TECHNICAL BULLETIN

* Supersedes Technical Bulletin TB600-007R1, dated 13 April 2006. Revised to correct tooling part numbers and re-sequence assembly steps. Aircraft that are in compliance with TB600-007R1 meet the intent of this revision.

FUSELAGE AFT SECTION AND TAILBOOM MODIFICATION

Model 600N Helicopters, serial number RN003 thru RN066 and RN068.

Figure 1. Location of Fairings

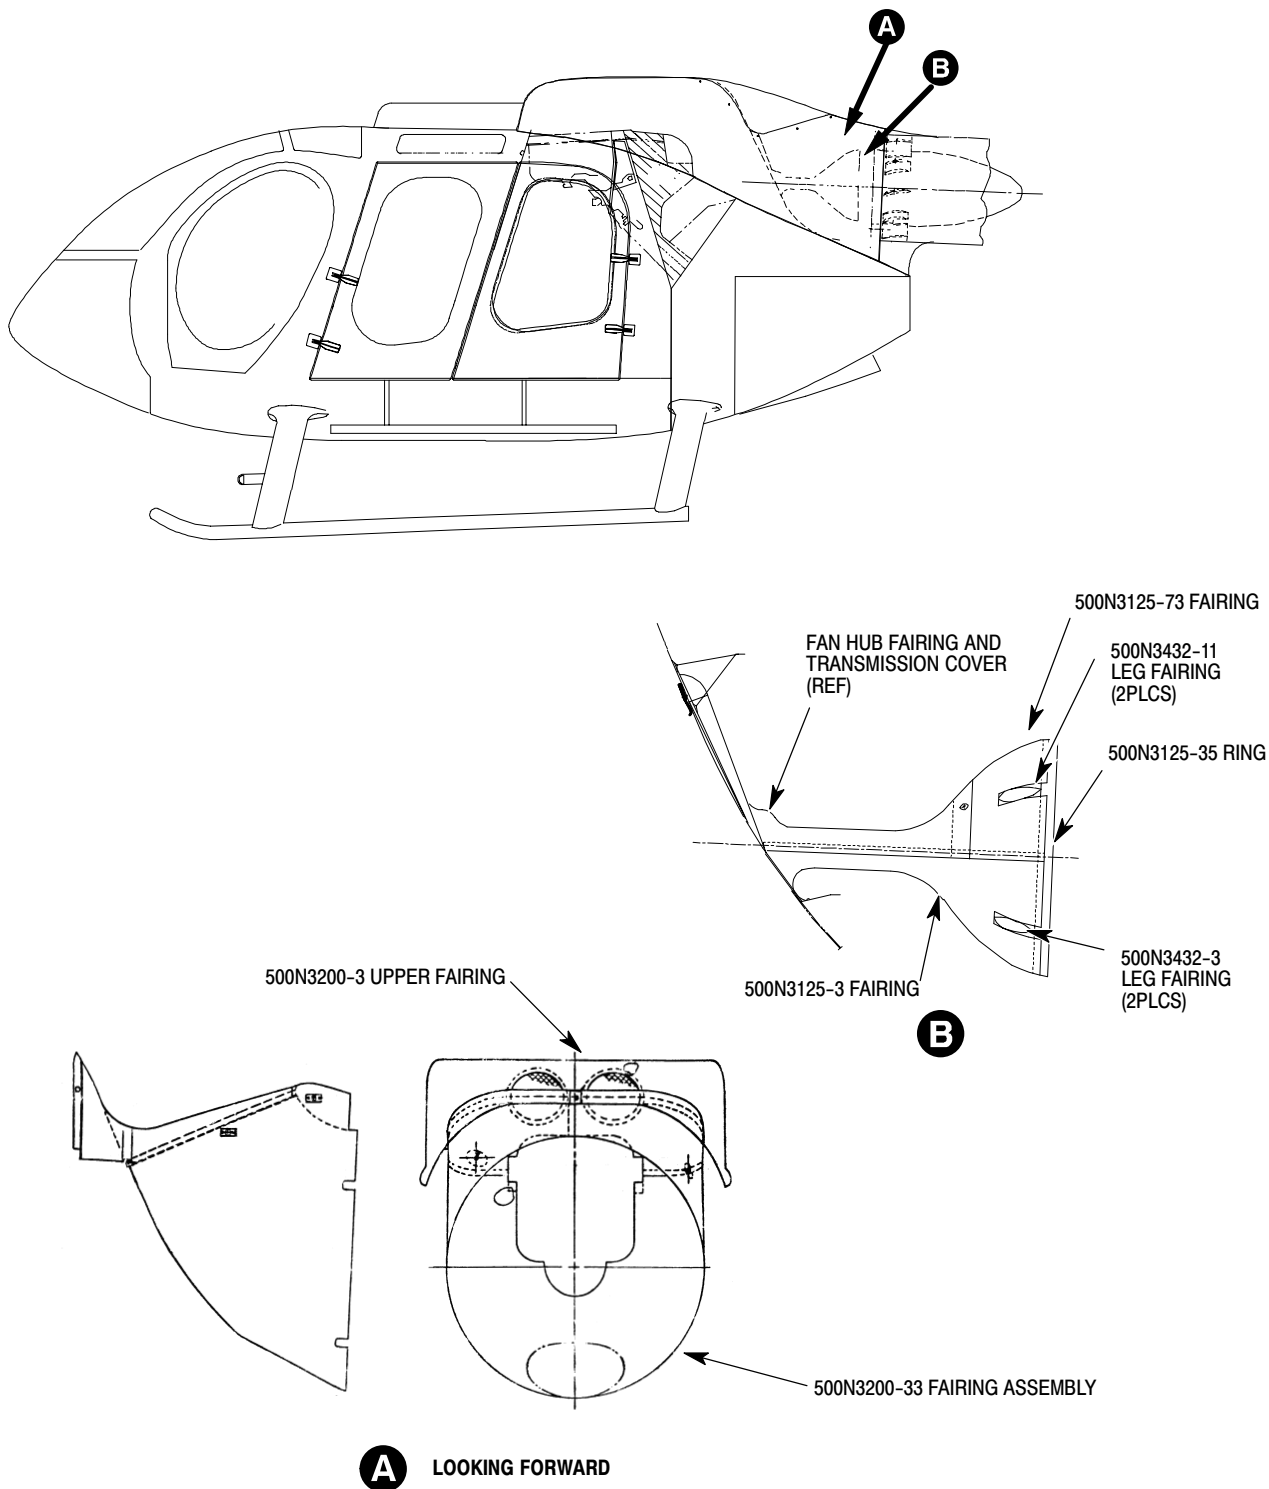
- (a). Apply heat and use a wedge to separate upper fairing (P/N 500N3200-3 and fairing assembly (P/N 500N3200-33) from forward lower end of fairing (P/N 500N3125-3).
- (b). If necessary, apply heat to adhesive bonding fairing (P/N 500N3125-73) and fairing (P/N 500N3125-3) to ring (P/N 500N3125-35) and fan support. Remove fairing (P/N 500N3125-35) and ring. Remove leg fairings (P/N 500N3432-3, -11).
- (c). Remove rivets attaching upper fairing (P/N 500N3200-3) to longerons and fan support frame.
- (d). Soften adhesive by applying heat and remove upper fairing (P/N 500N3200-3).

- (e). Remove fairing assembly (P/N 500N3200-33).
 - 1). Remove rivets attaching fairing assembly to fan support frame.
 - 2). Apply heat to bottom of forward lower edge of fairing assembly) and peel fairing away from flange.
 - 3). Apply heat to sides of fairing assembly and peel fairing away from stringers.
 - 4). Apply heat to top of aft lower edge of fairing assembly and separate from fan support frame using skin wedge.
 - 5). Remove and discard rivets, pins, collars, two fittings (P/N 500N3130-3) and tube (P/N 500N3130-7). (Ref. Figure 2, View C-C).
 - 6). Remove fairing assembly from helicopter. (Ref. Figure 1.)

- (5). Install fairings.
 - (a). Attach fairing assembly (P/N 500N3200-33) to fan support frame using NAS1738B4-6 rivets .
 - (b). Position upper fairing (P/N 500N3200-3) on fuselage. (Ref. Figure 1.)

- (c). Bond upper fairing and fairing assembly using epoxy adhesive (EA9309.3) per manufacturers instructions.
 - (d). Attach upper fairing (P/N 500N3200-3 to longerons and fan support frame using NAS1720KE4L2A rivets .

Figure 2. Fuselage Aft Section Parts Removal and Modification (Sheet 1 of 2)

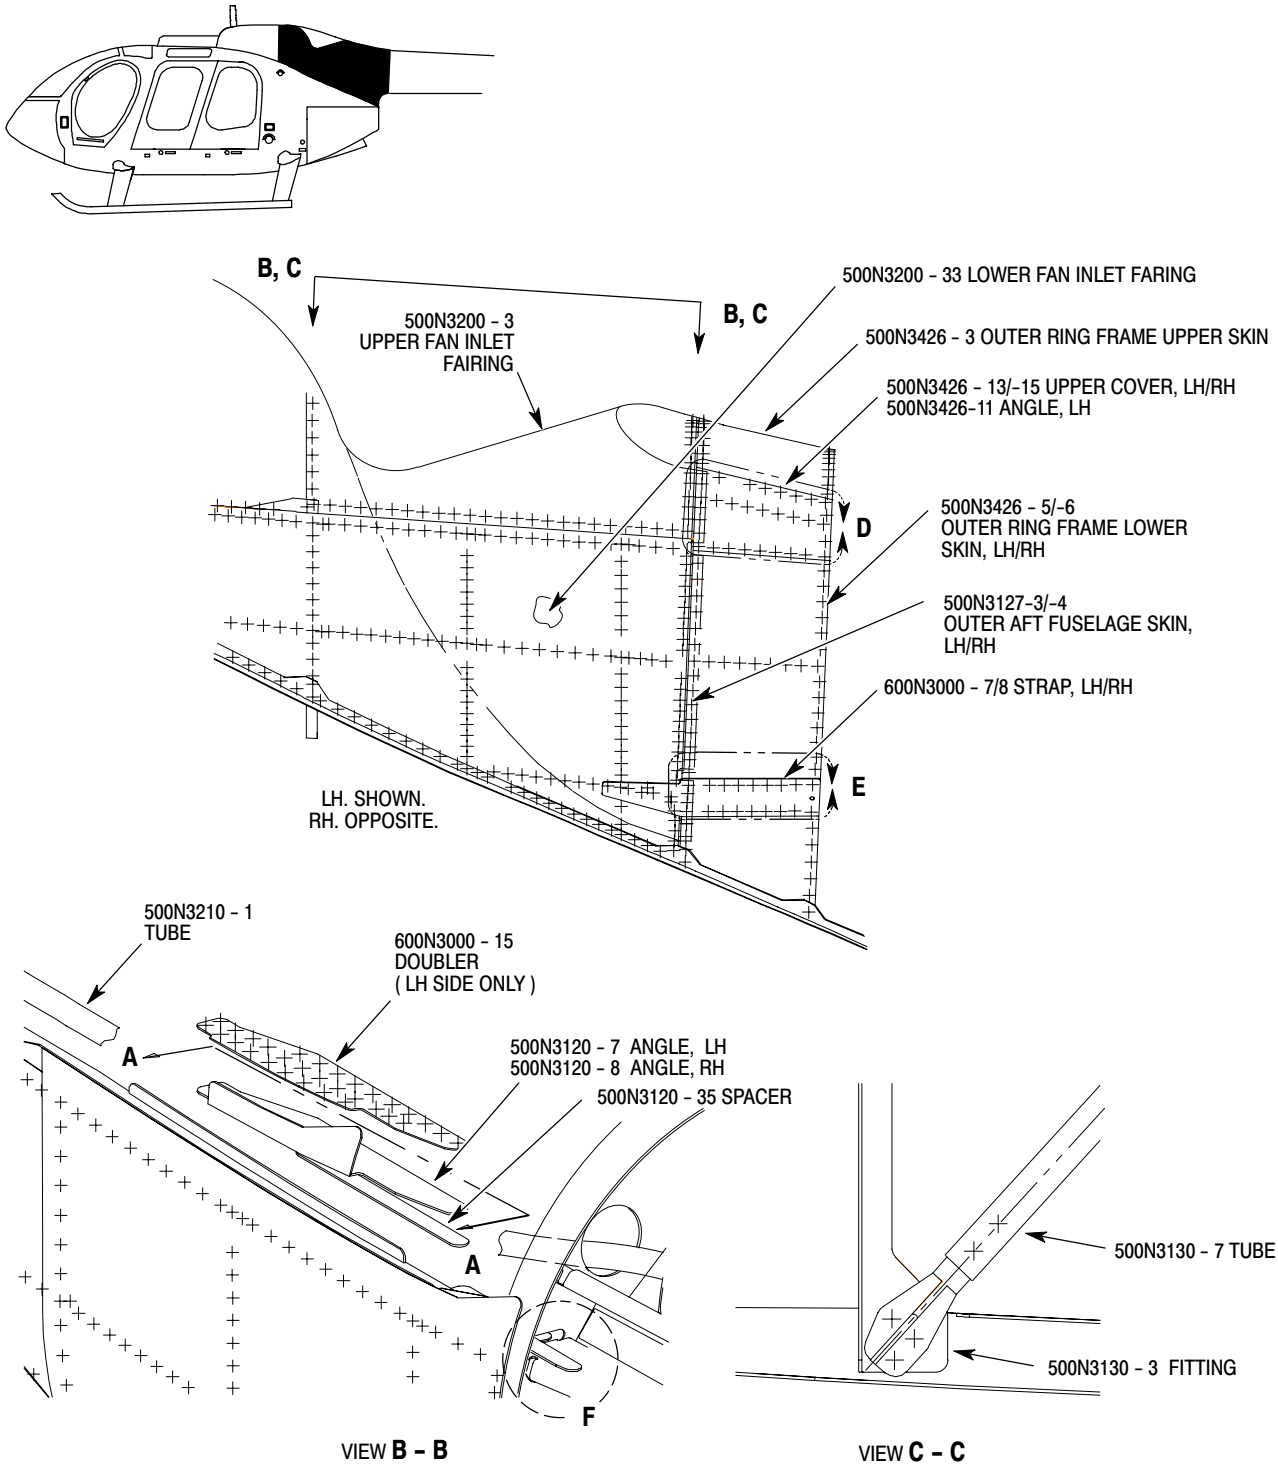
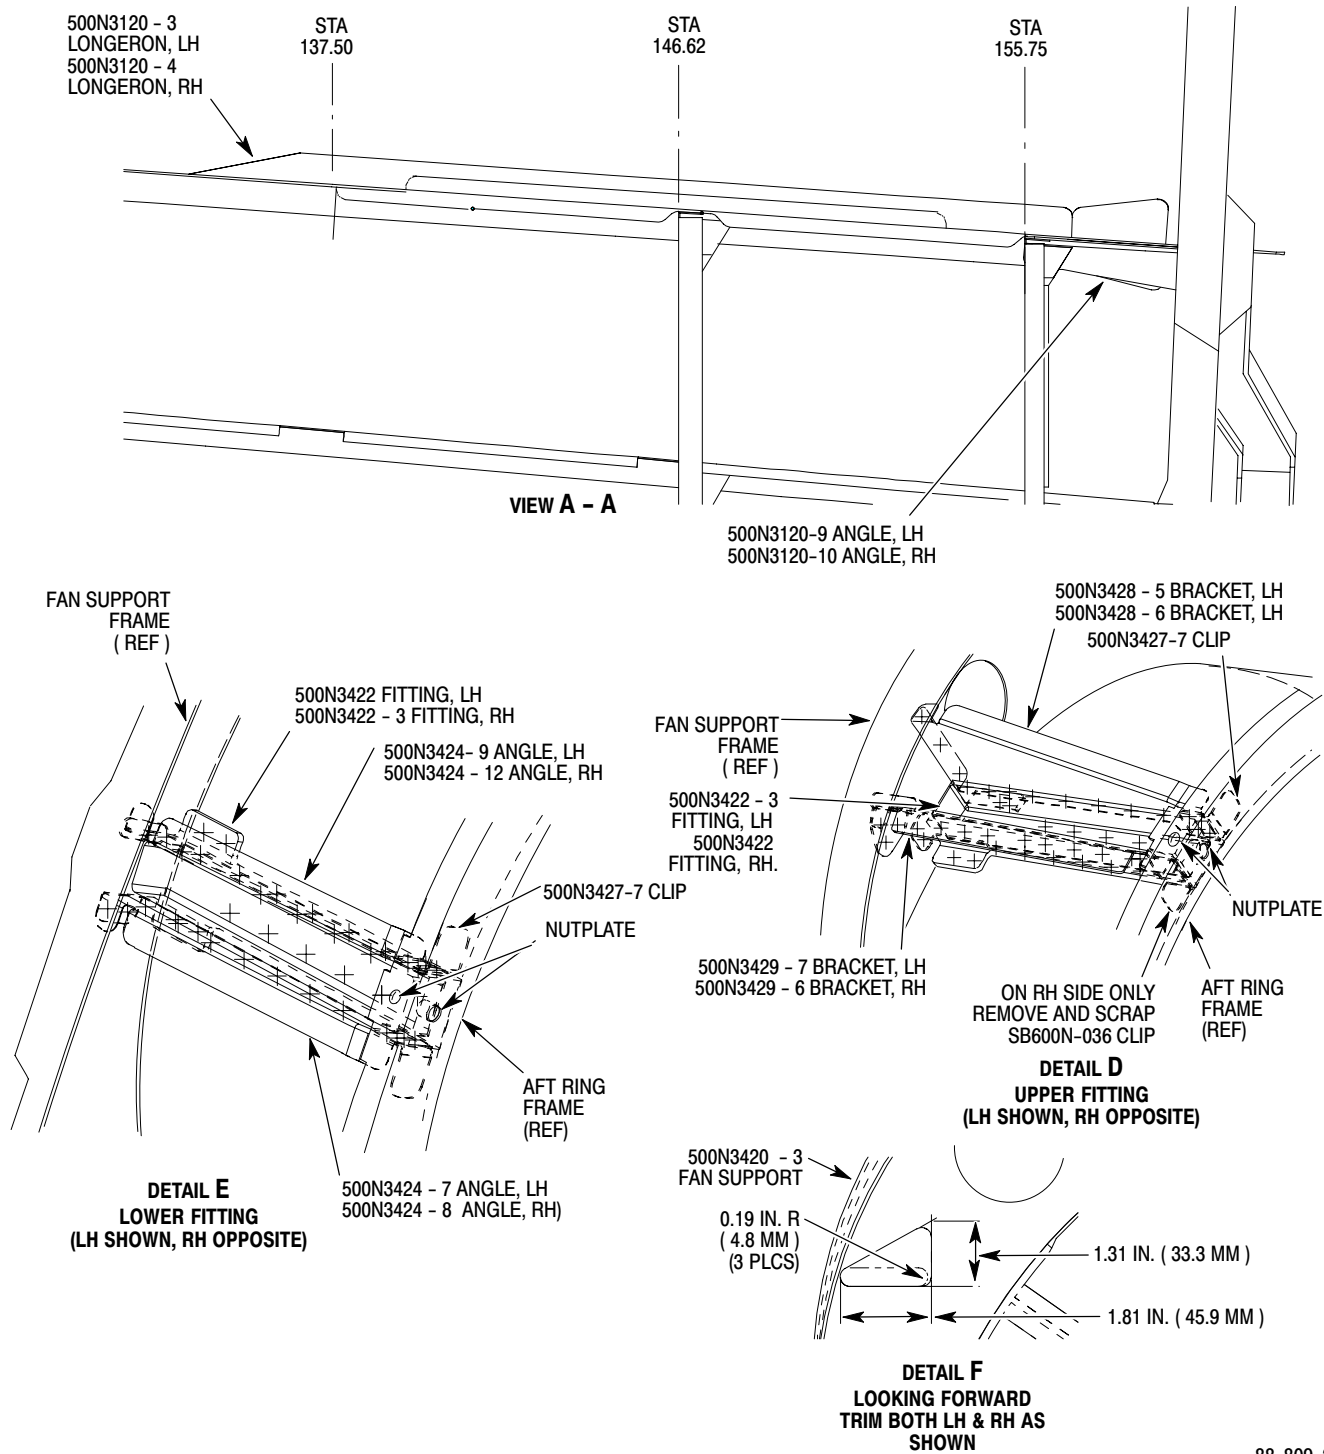
- (a). Remove rivets and remove and retain outer ring frame upper skin (P/N 500N3426-3).
- (b). Remove rivets and remove and retain LH and RH upper cover (P/N 500N3426-13/-15).
- (c). Remove rivets and remove and retain LH angle (P/N 500N3426-11).
- (d). Remove rivets and remove and retain LH and RH strap (P/N 600N3000-7/-8).
- (e). Remove rivets and remove and retain LH and RH outer ring frame lower skin (P/N 500N3426-5/-6).
- (f). Remove rivets and remove and retain LH and RH outer aft fuselage skin (P/N 500N3127-3/-4).

- (1). Remove and retain four nutplates from back of outboard facing flange of aft ring frame (Ref. Details D and E).
- (2). Remove upper and lower tailboom attach fittings.

- (a). Remove rivets and remove and discard LH upper fitting (P/N 500N3422-3) and RH upper fitting (P/N 500N3422), LH bracket (P/N 500N3429-7), RH bracket (P/N 500N3429-6), nutplates, and clip (added by Service Bulletin SB600-036). Remove and retain LH bracket, (P/N 500N3428-5) and RH bracket, (P/N 500N3428-6). (Ref. Detail D.)

- (b). Remove rivets and remove discard LH lower fitting (P/N 500N3422), RH lower fitting (P/N 500N3422-3) and nutplates. Remove and retain LH angle (P/N 500N3424-9, RH angle (P/N 500N3424-12, LH angle 500N3424-7), and RH angle (P/N 500N3424-8). (Ref. Detail E.)

- (5). Remove longerons and associated parts.
 - (a). Remove rivets and remove and discard LH doubler (P/N 600N3000-15, LH angle (P/N 500N3120-7), RH angle (P/N 500N3120-8), and spacers (LH and RH) (P/N 500N3120-35). (Ref. View B-B.)

- (b). Remove rivets and remove and discard angles (P/N 500N3120-9, -10) and longerons (P/N 500N3120-3, -4). (Ref. View A-A.)

- (6). Rework fan support.
 - (a). Trim both sides of fan support as shown. (Ref. Detail F.)
 - (b). Apply chemical coating to reworked areas per manufacturer's instructions.
 - (c). Apply primer to reworked areas per manufacturer's instructions.
- (7). Install new longerons (P/N 600N3120-1/-2) and angles (P/N 500N3120-9/-10).
 - (a). Position new longerons on airframe. (Ref. View A-A.)
 - (b). Temporarily install LH and RH outer aft fuselage skins (P/N 500N3127-3/-4) and match drill attach holes in longerons.
 - (c). Match drill nutplate attach holes in longerons.
 - (d). Remove LH and RH outer aft fuselage skins.

Figure 3. Fuselage Aft Section Modification (Sheet 1 of 5)

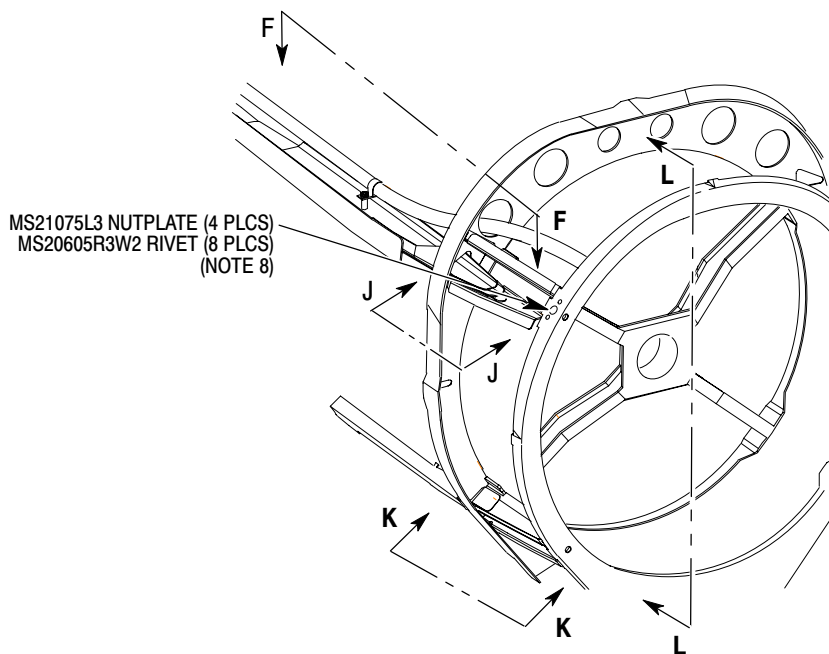
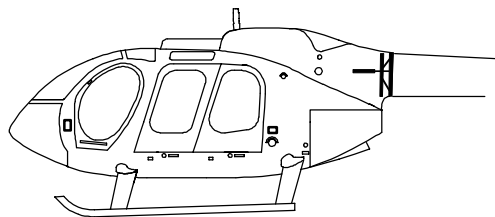
- (a). Touch countersink and double flush install two MS20426A4-1 rivets in holes adjacent to each upper tailboom attach hole in aft ring frame.
- (b). Position new brackets (P/N 500N3429-9/-10), new fittings (P/N 600N3422-1) and retained brackets (P/N 500N3428-5/-6) between aft ring frame and fan support frame.
- (c). Position two upper clips (P/N 500N3427-7) and two lower clips (P/N 500N3427-9) and clamp into place.
- (d). Mark location for all rivet holes on brackets, fittings and clips.
- (e). Remove brackets, fitting and clips.

- (f). Drill rivet holes in new fitting using drill press.
- (g). Deburr holes and remove all debris.
- (h). Temporarily install clips, brackets and fittings with clecos.
- (i). Match drill tailboom attach bolt hole in aft end of each fitting. (Ref. View L-L.)
- (j). Remove brackets, fitting and clips.
- (k). Deburr holes and remove all debris from fittings.
- (l). Install clips, brackets and fittings with rivets, as shown. (Ref. View J-J.)

Check fit clearance between rivet tails and nutplate retainer before final installation. Buck rivets again, if needed, to provide clearance for nutplate retainer.

- (a). Touch countersink and double flush install two MS20426A4-1 rivets in holes adjacent to each upper tailboom attach hole in aft ring frame.
- (b). Position new fittings (P/N 600N3422-1) and retained angles (P/N 500N3424-7/-8/-9/-12) between aft ring frame and fan support frame.
- (c). Position two upper clips (P/N 500N3427-7) and two lower clips (P/N 500N3427-7) and clamp into place.
- (d). Mark location for all rivet holes on brackets, fittings and clips.
- (e). Remove brackets, fitting and clips.

- (m). Install nutplate (P/N MS21075L3) in fitting with rivets, as shown.
- (10). Install angles and spacers.
 - (a). Layout rivet hole pattern on longerons and drill pilot holes using #40 drill bit. (Ref. View F-F.)
 - (b). Position aft section angles (P/N 600N3121-1/-2), spacers (P/N 600N3122-3), angles (P/N 600N3123-1/-2) and angles (P/N 600N3124-1/-2) in position on longeron as shown and clamp securely into place. (Ref. Section H-H.)

- Maintain 0.010-0.025 inch (0.254-0.635mm) gap between longeron and spacer (P/N 600N3122-3).
- Shim as required with 2024-T3 aluminum sheet to eliminate gap between spacers (P/N 600N3122-3) and brackets (P/N 500N3429-9/-10).
- Fabricate 0.063 inch (1.60 mm) shim for specific rivet location as shown. (Ref. View F-F.)
 - (c). Transfer holes to all angles and spacers.
 - (d). Drill and cleco rivet holes through angles and spacers. (Ref. View F-F.)
 - (e). Remove angles and spacers and deburr rivet holes. Touch up with primer as needed.
 - (f). Install longerons in airframe and install nutplates on longerons.
 - (g). Match drill and temporarily install angles (P/N 500N3120-9/-10).
 - (h). Install angles and spacers on longerons and attach with rivets, as shown. (Ref. View F-F.)
 - (i). Permanently install LH and RH outer aft fuselage skins (P/N 500N3127-3/-4).

When cold-working the rivet holes, ensure holes do not get oversized. Ream to proper size as per Notes 1 and 2 of Figure 3.

- (j). Cold work 12 rivet holes (each side) using proper sized tooling.
- (k). Install 12 rivets (Ref. Sheet 2 of 5)
- (11). Using drill fixture 600N3510-1-DJ1, enlarge four tailboom attach holes in aft ring frame. (Ref. View L-L.)

1. COLD WORK RIVET HOLES USING 4 - 0 - N SIZED TOOLING AND CBS-4-0-N SLEEVES. REAM TO 0.128 IN. (3.25 MM) AFTER COLD WORK.
2. COLD WORK RIVET HOLES USING 4 - 2 - N SIZED TOOLING AND CBS-4-2-N SLEEVES. REAM TO 0.159 IN. (4.04 MM) AFTER COLD WORK.

3. TRIM FITTING FOR RH. INSTALLATION AS REQUIRED TO CLEAR STRUCTURE. BLEND TRANSITIONS AND RADIUS ALL CORNERS. FINISH WITH CHEMICAL COATING AND PRIMER.

4. TRIM TO MAINTAIN 0.010 - 0.025 IN. (0.254 - 0.635 MM) GAP BETWEEN 600N3120 - 1 / -2 LONGERON AND 600N3122 - 3 SPACER (REF. VIEW N).
5. SHIM AS REQUIRED WITH 2024 - T3 AL SHEET TO ELIMINATE GAP BETWEEN 600N3122 SPACER AND 500N3429 BRACKET. FABRICATE SHIM TO SPAN FROM FORWARD PIN RIVETS AND AFT TO LAST RIVET ON 600N3122 SPACER. WIDTH TO MATCH SPACER.

6. FABRICATE 0.063 IN. (1.60 MM) SHIM FOR THIS RIVET LOCATION.
7. MATCH DRILL TO 600N3422 FITTING. INSTALL NUTPLATE RETAINER IN 600N3422 FITTING PER MANUFACTURERS INSTRUCTIONS PER DIMENSIONS SHOWN USING NUTPLATE RETAINER INSTALLATION TOOLING.

8. REMOVE AND RETAIN FOUR NUTPLATES. REINSTALL NUTPLATES WITH MS20605R3W2 RIVETS AFTER INSTALLATION OF TAILBOOM ATTACH BOLT NUTPLATES.
9. MHS5583-5 COLLARS MAY BE SUBSTITUTED FOR MHS5582-5 COLLARS IF THERE IS NO MISALIGNMENT AND SHORT THREAD PROTRUSION.

**VIEW K - K
 LOWER FITTING
 (LH SHOWN, RH OPPOSITE)**

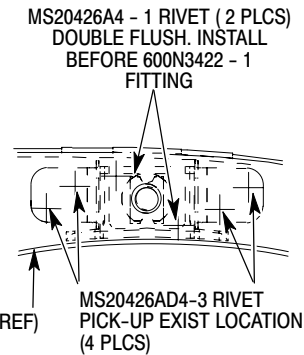
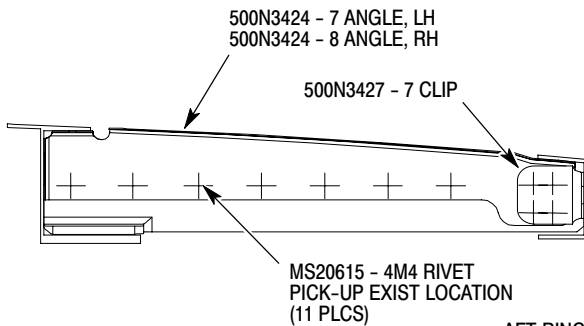
■ (9). Position lower tailboom attach fittings. (Ref. View K-K.)

- (g). Deburr holes and remove all debris.
- (h). Temporarily install clips, brackets and fittings with clecos.
- (i). Match drill tailboom attach bolt hole in aft end of each fitting. (Ref. View L-L.)
- (j). Remove brackets, fitting and clips.
- (k). Deburr holes and remove all debris from fittings.
- (l). Install clips, brackets and fittings with rivets, as shown. (Ref. View K-K.)

Figure 4. Fuselage Aft Section Rework and Installation of Parts

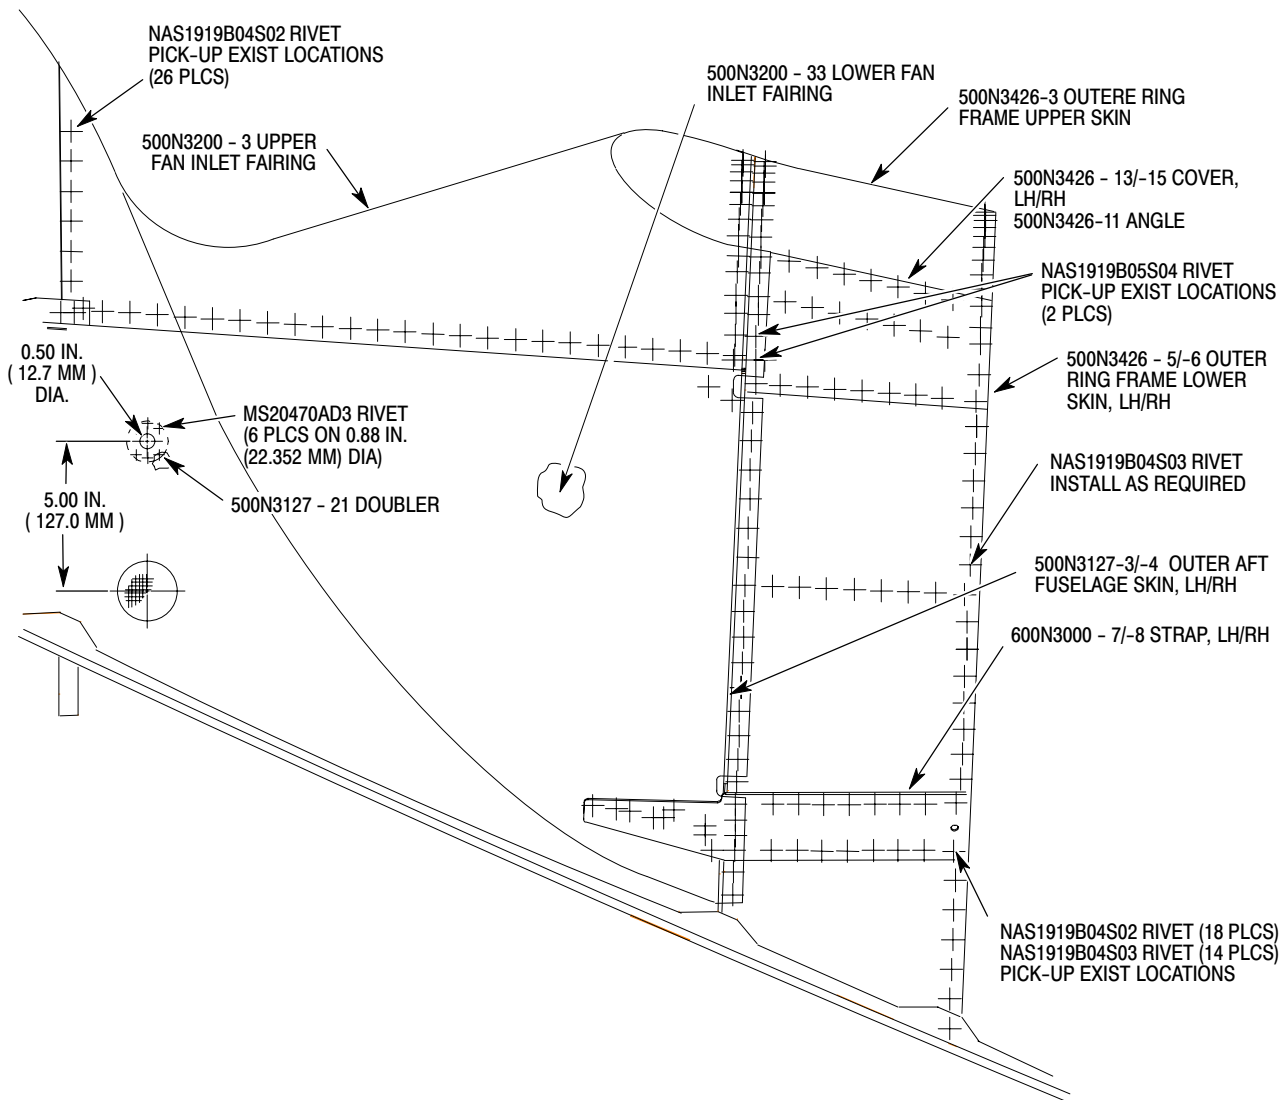
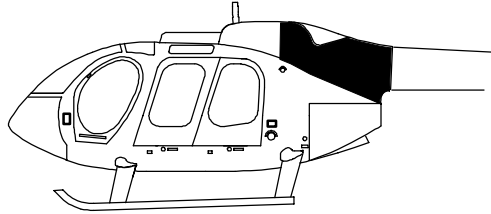
- (15). Install inspection hole.
 - (a). Locate and drill one 0.50 inch (12.7mm) inspection hole (L137) in left side of fuselage.
 - (b). Apply chemical coating and primer to inspection hole per manufacturer;s instructions.
 - (c). Install doubler with six MS20470AD3 rivets.

NOTE: Seal exterior sheet metal parts with sealing compound per manufacturer's instructions.
